Service Bulletin

Card Tipping Position / Grip Motor Adjustment, ExpressCard 2000 Document Number D998200258-10

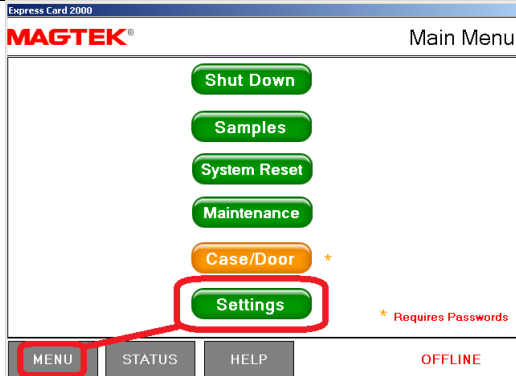
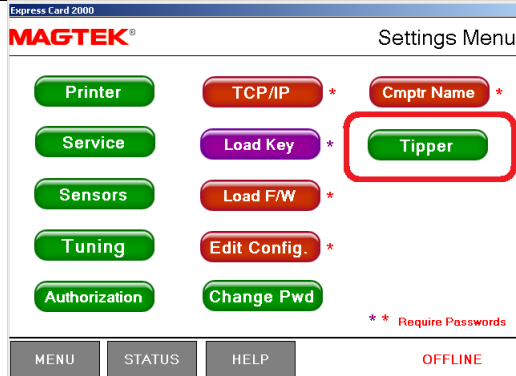
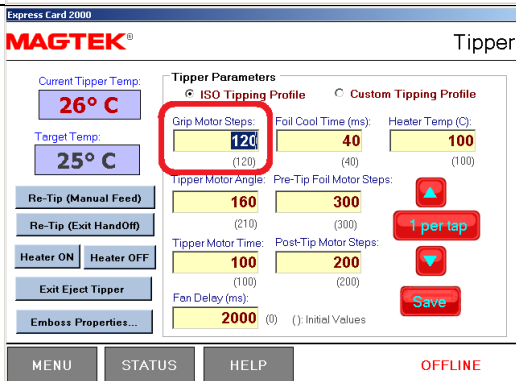
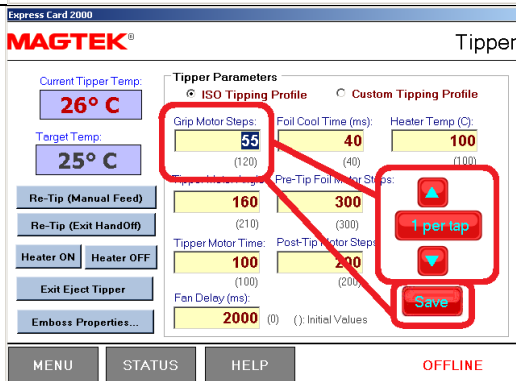
Follow the steps in this service bulletin to change the Gripper Motor Steps setting on ExpressCard 2000 (EC2000) devices. This addresses some situations where cards fail to eject properly into the card output bin. This procedure changes the position where the EC2000 stops the card on the ramp before tipping, providing a more centered grip by the gripper roller.

1) From the device touchscreen, select Menu > Settings.		2) Select Tipper.	
3) Select the number in the Grip Motor Steps field.		4) Use the 1 per tap and arrow buttons to change the setting to a starting point of 55, then press the Save button.	
5) Create a test card, using the customer design that has embossed text closest to the top of the card.		6) If the embossed text is not completely tipped, repeat these steps to adjust the Grip Motor Steps setting +1 at a time until the test succeeds.
